Federal Aviation Administration

[Docket No. FAA-2010-1101; Directorate Identifier 2009-CE-013-AD]

Airworthiness Directives; Cessna Aircraft Company Models 150, 152, 170, 172, 175, 177, 180, 182, 185, 188, 190, 195, 206, 207, 210, T303, 336, and 337 Airplanes

ACTION: Notice of proposed rulemaking (NPRM).

Figure 1. Diameter of seat pin locking engagement hole

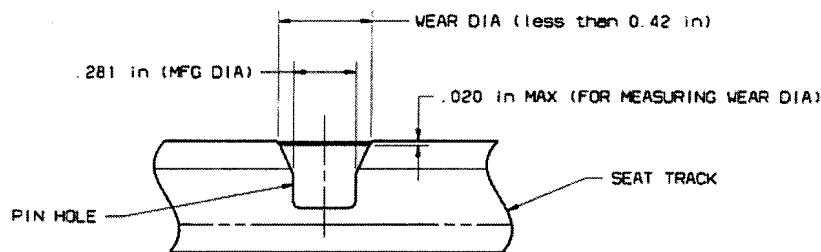
(4) Inspect the diameter of each seat locking pin engagement hole in the pilot and copilot seat rails for excessive wear. Due to wear on the rail surface at the hole opening, we allow this measurement 0.020 of an inch

below the surface of the rail. You must take this measurement somewhere between the surface of the rail or no more than 0.020 of an inch below the surface of the rail.

(i) If the diameter of any of the holes is 0.42 of an inch or more (see figure 1), before further flight, replace the rail.

Figure 2. Seat locking pin depth engagement

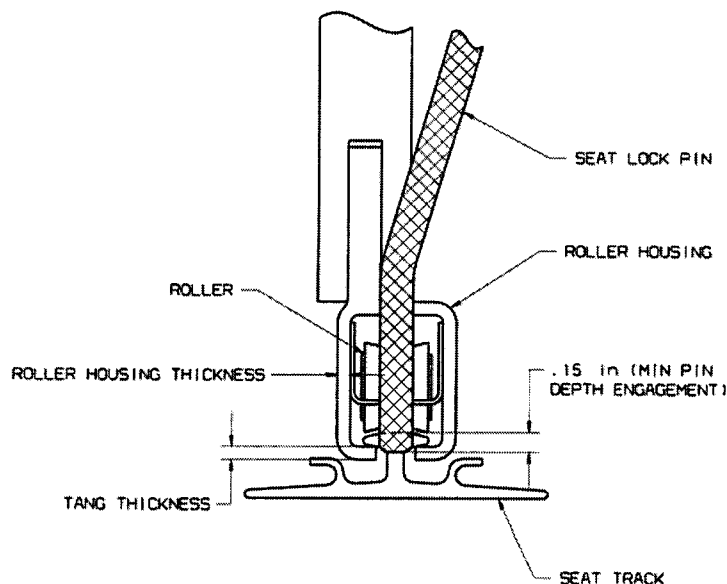
(2) Lift up the forward edge of each seat to eliminate vertical play of the seat locking pin

in the engagement hole, and from this position, inspect the depth of engagement of each seat locking pin (see figure 2). If the rail is worn, this depth is measured from the worn surface, not the manufactured surface.

(i) If engagement of any of the seat locking pins measures less than 0.15 of an inch, before further flight, replace or repair any seat components necessary to achieve a seat pin engagement of a minimum of 0.15 of an inch.

Figure 3. Closeup of seat roller housing and tang thickness

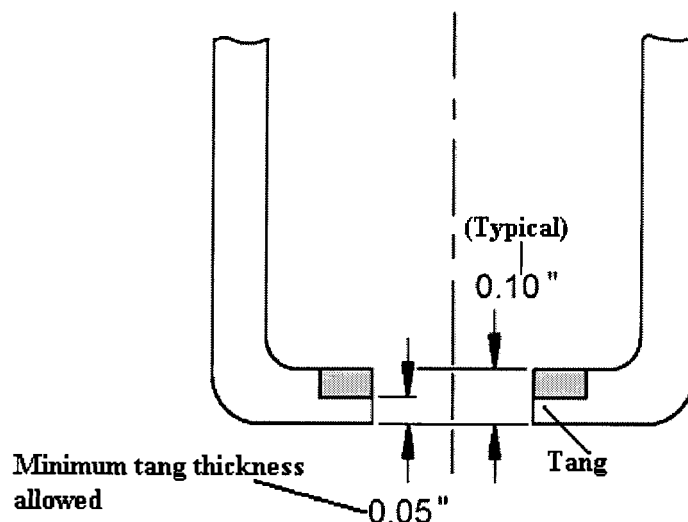
(6) Inspect the thickness of the tang (see figure 2 and figure 3). Due to wear of the tang chafing against the seat rail, measure the tang thickness where the tang inner edges contact the seat rail.

(i) If the tang thickness measures less than 0.05 of an inch, before further flight replace the roller housing.

Figure 4. Closeup of seat roller housing and tang gap width

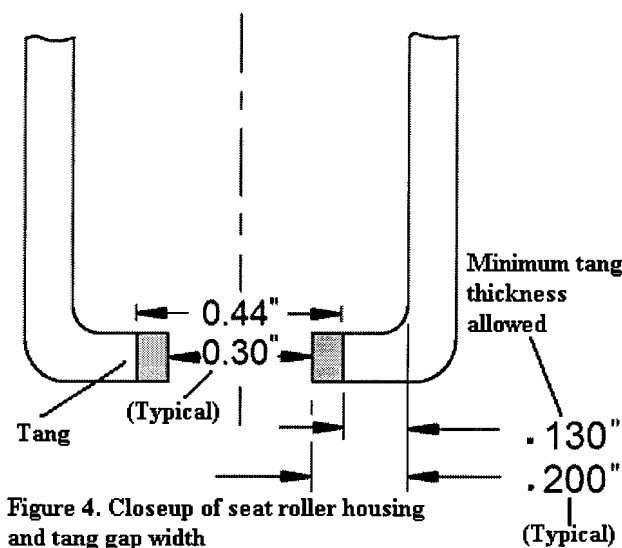
(7) Inspect the inner edges of the tangs. Due to wear or deformation of the tangs, measure the distance from one tang inner

edge to the other tang inner edge (see figure 4).

(i) The maximum distance allowed between tang edges is 0.44 inches. If the

distance between tang inner edges measures 0.44 of an inch or more, before further flight, replace the roller housing.

(ii) The minimum measurement allowed for the remaining tang is 0.130 inches remaining on either of the tangs, from the inner edge of the tang to the bend of the roller housing. If the measurement is less than 0.130 inches on either of the tangs, before further flight, replace the roller housing.

Figure 5. Seat rail

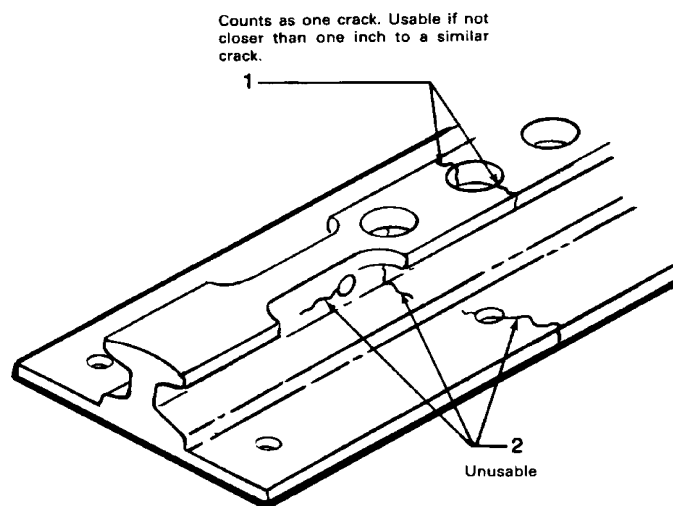
(9) Visually inspect the seat rails for cracks.

(i) If there are seat rail cracks that exceed the crack criteria in figure 5, before further flight, replace the seat rail.

REPLACE SEAT RAIL WHEN:

- (1) Any portion of web or lower flange is cracked (index 2).
- (2) Any crack in crown of rail is in any direction other than right angle to length of rail.
- (3) Number of cracks on any one rail exceeds four, or any two cracks (index 1) are closer than one inch.
